STATE OF WASHINGTON  
DEPARTMENT OF ECOLOGY

**Re: Opinion Pursuant to WAC 173-340-515(5) on Soil Vapor Cleanup Work Plan for the following Hazardous Waste Site:**

- **Site Name:** Classic Cleaners Everett
- **Site Address:** 7601 Evergreen Way B4, Everett, WA 98203
- **Facility/Site No.:** 1382746
- **Cleanup Site ID No.:** 4690
- **VCP Project No.:** NW2745

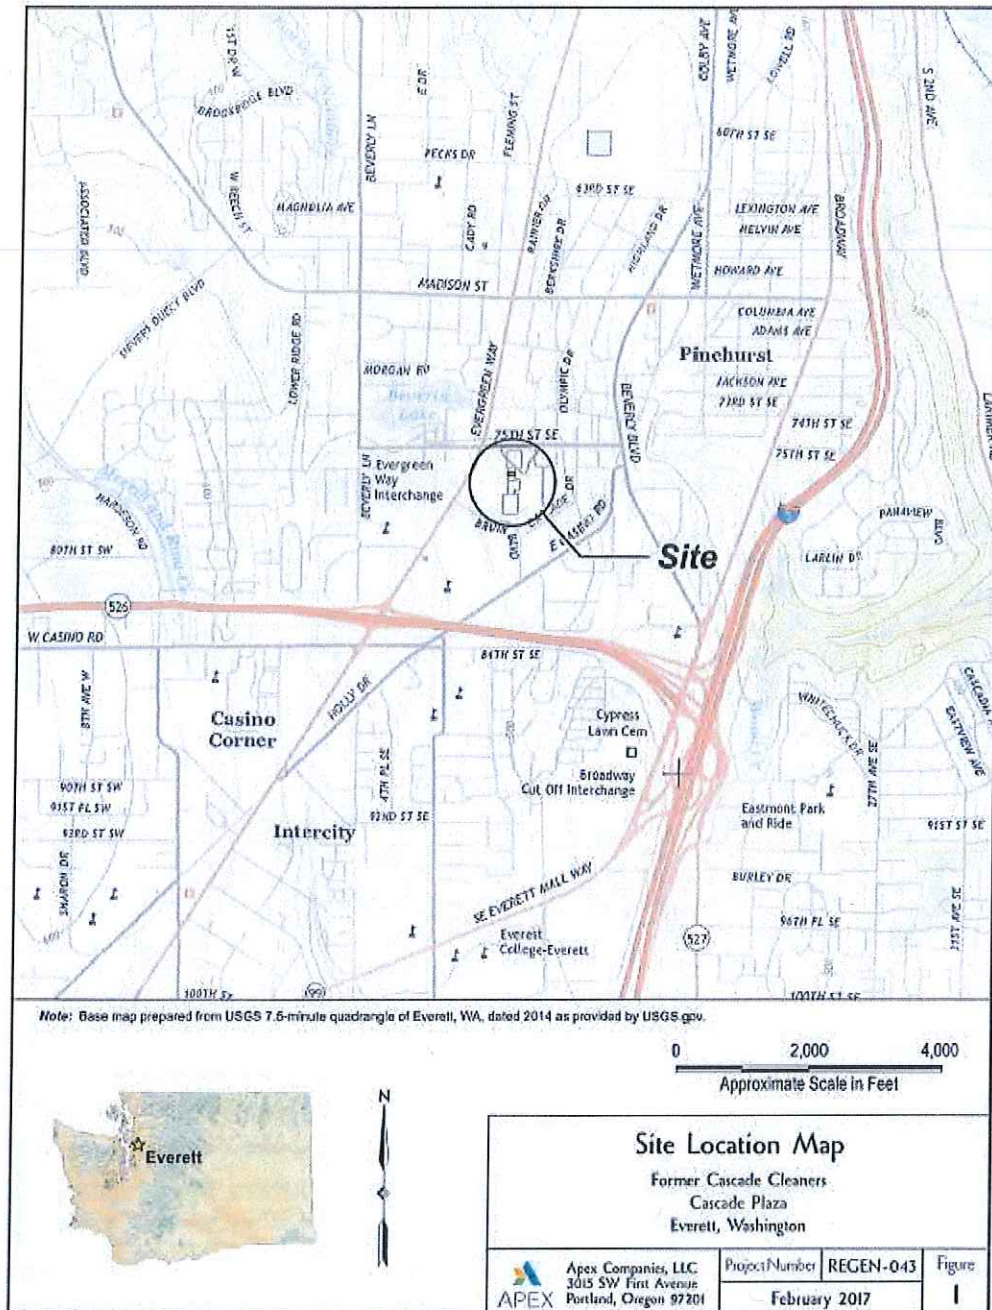
- Soil vapor data presented in the FS/CAP (**Enclosure A, Figure 2**) poses the following key issues:
  - PCE soil vapor concentrations above the Method B sub-slab screening level of 320  $\mu\text{g}/\text{m}^3$  ranged from 990  $\mu\text{g}/\text{m}^3$  to 10,000  $\mu\text{g}/\text{m}^3$ , approximately 3 to 31 times the screening level.

- A comparison of soil vapor samples from depths of 3 inches and 3 feet below the building floor slab show the highest concentrations at the 3-foot depth. These data indicate the likely presence of a residual source of PCE in soil at depths that have not yet been assessed. Supplemental evaluation of PCE in soil within the building floor should be considered for the potential effects of stratigraphy on contaminant distribution, including the transition between weathered glacial till and underlying dense till.

- The adequacy of the three existing monitoring wells on the east side of the building (MW-2, MW-3, and MW-4) to document the presence or absence of PCE impacts to ground water has not been demonstrated. Prior Ecology opinion letters recommended installation of an additional monitoring well within the building footprint, as close as possible to the highest detection of PCE in soil (**Enclosure A, Figure 2**). No additional monitoring well has been installed to date.

- Install additional monitoring well(s) at the source area (**Enclosure A, Figure 2**) to evaluate the contamination status in this location.
- Prepare updated hydrogeologic cross sections along and perpendicular to the predominant ground water flow direction, including:
  - Vertical scale in sea level elevation (NAVD88 vertical datum)
  - Thicknesses of the building floor slab, subgrade, and underlying stratigraphic layers, including weathered till versus dense till
  - Monitoring wells MW-1 and MW-4 (downgradient cross section), including well screen intervals
  - Seasonal high and low ground water levels
  - Soil vapor sample depths and PCE concentrations
  - Soil sample depths and PCE concentrations
  - Ground water sample depths and PCE concentrations, including the samples from borings and temporary monitoring wells
